SCEC – K&A Reviewed
Code B – Approved with Comments (Do not Resubmit)

PROJECT: JEDDAH OPERA HOUSE

TITLE: OPERA BUILDING
VERTICAL TRANSPORTATION
PART 001
PLANS - LIFT SHAFT (L01)

DRAWING No: JOH-OTS-S5-01-056-001-ZZ-SD-VT-011000 REV: S00

1 Hoist Way Plan At "G" Floor - ELEV-L1

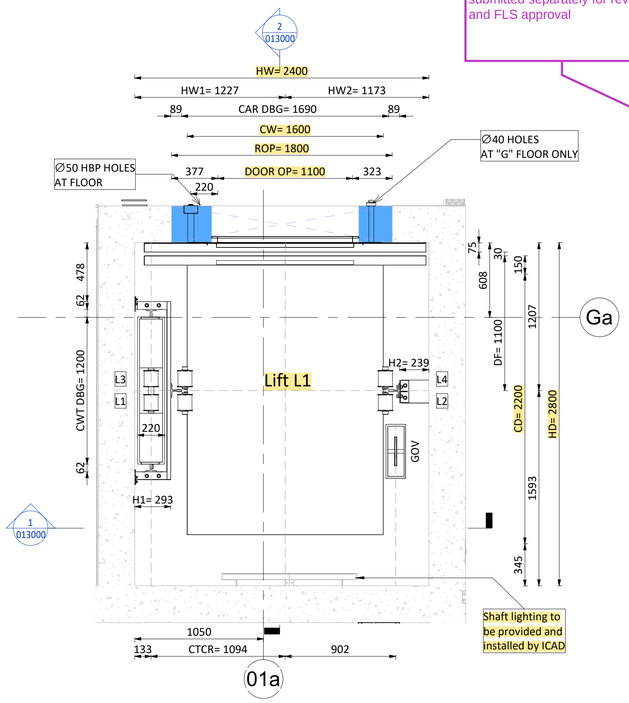
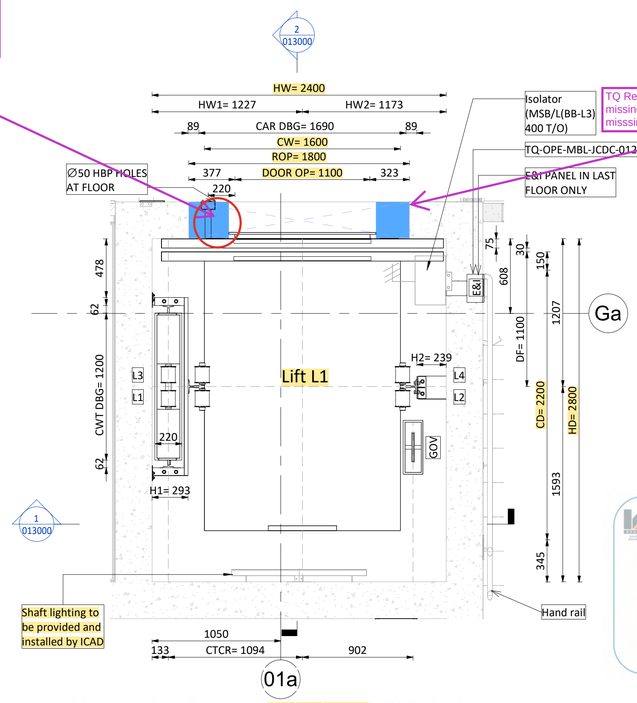
fire stop application detail to be submitted separately for review and FLS approval

2 Hoist Way Plan At "1" Floor - ELEV-L1

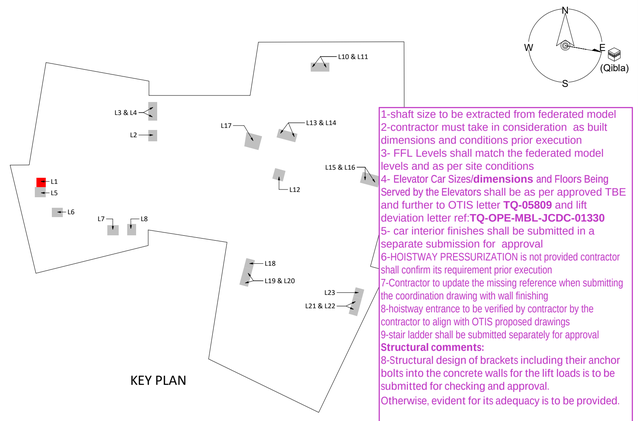
TQ Reference is missing , legend is missing ,

5 Top Hoist Way Hook Plan - ELEV-L1

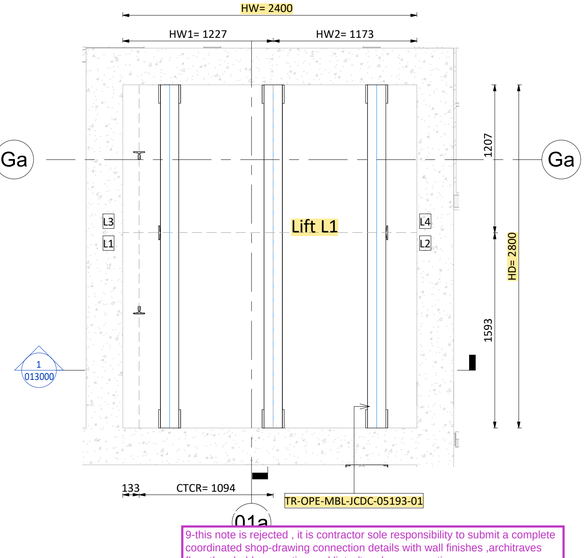
9-this note is rejected , it is contractor sole responsibility to submit a complete coordinated shop-drawing connection details with wall finishes ,architraves floor threshold connection and linter/top door connection
